REMARKS/ARGUMENTS

Amendments to the Drawings

ANNOTATED SHEETS/
REPLACEMENT SHEETS
FIGS. 8–13, 14B

Annotated Sheets Showing Changes

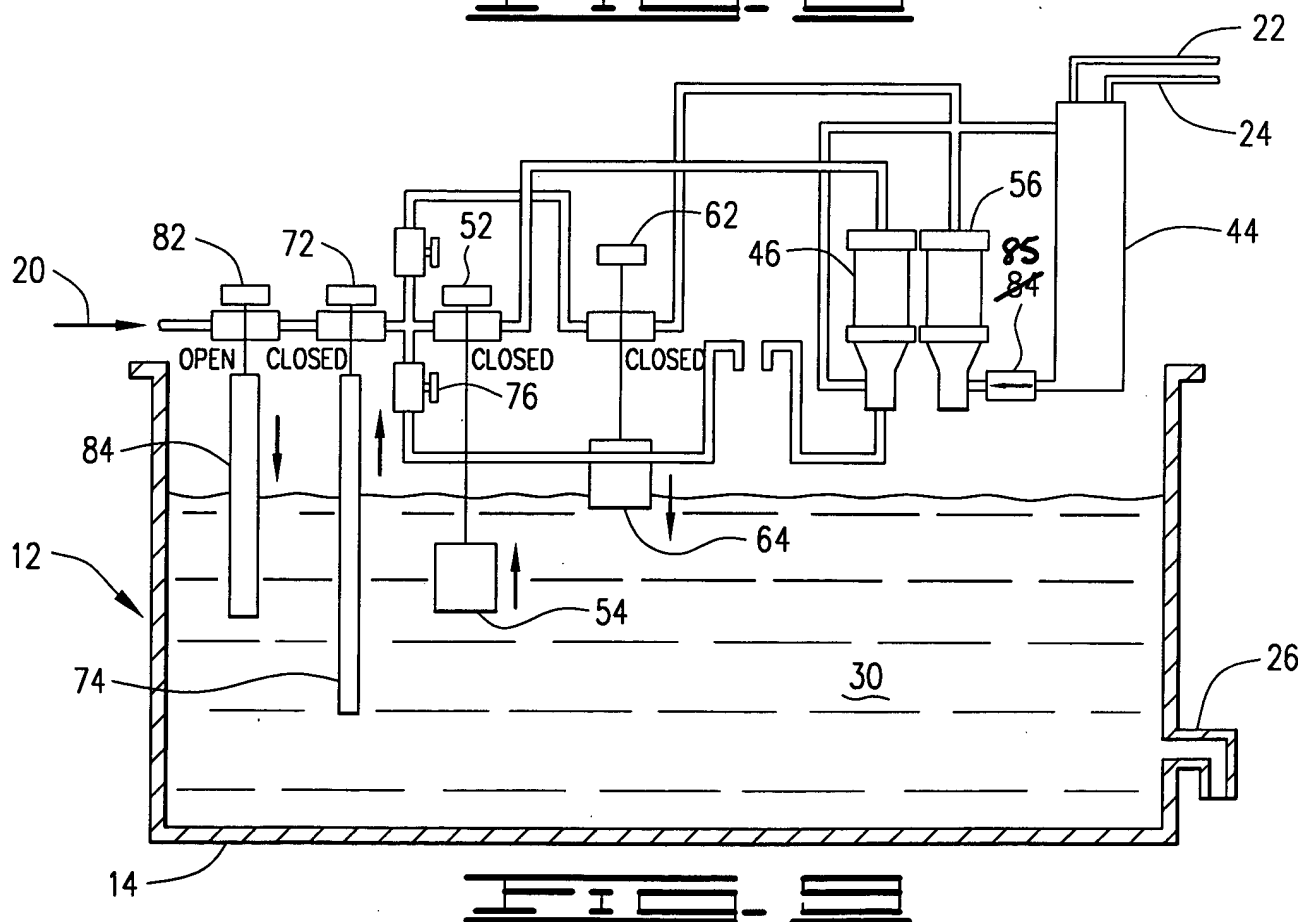
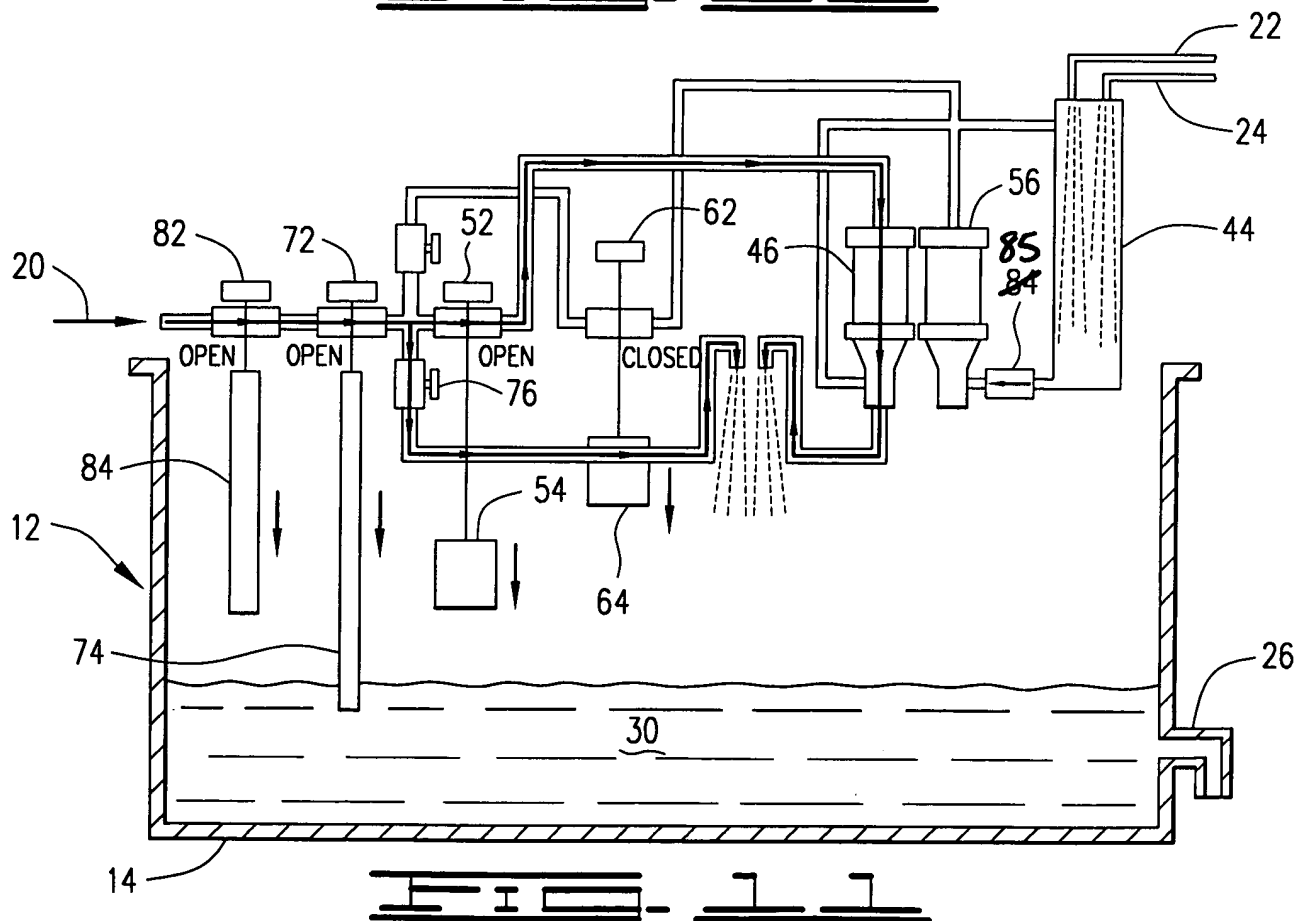
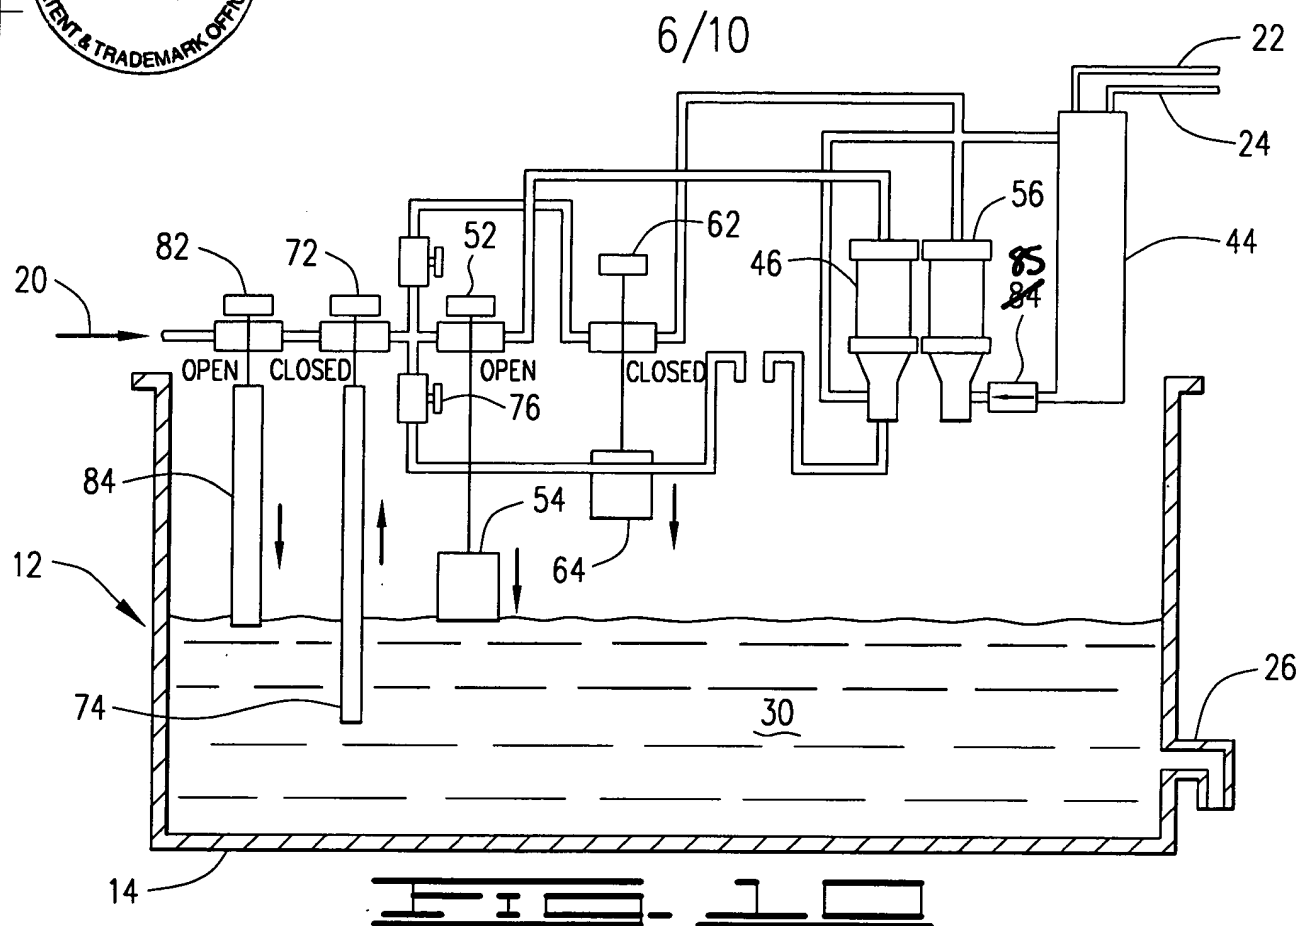
The attached sheets of drawings include changes to Figs. 8, 9, 10, 11, 12, and 13 and replace the original sheets including these Figures. In Figs. 8-13, there were previously two elements designated by numeral 84. One of these elements, a check valve, has been renumbered as element 85. In Figs. 12 and 13, there were two elements designated by numeral 30. One of these elements, the activated solution, has been renumbered as element 29. Finally, in Fig. 14B, the first text box was changed to read, in part, “(SEE FIGURE NO. 10).”
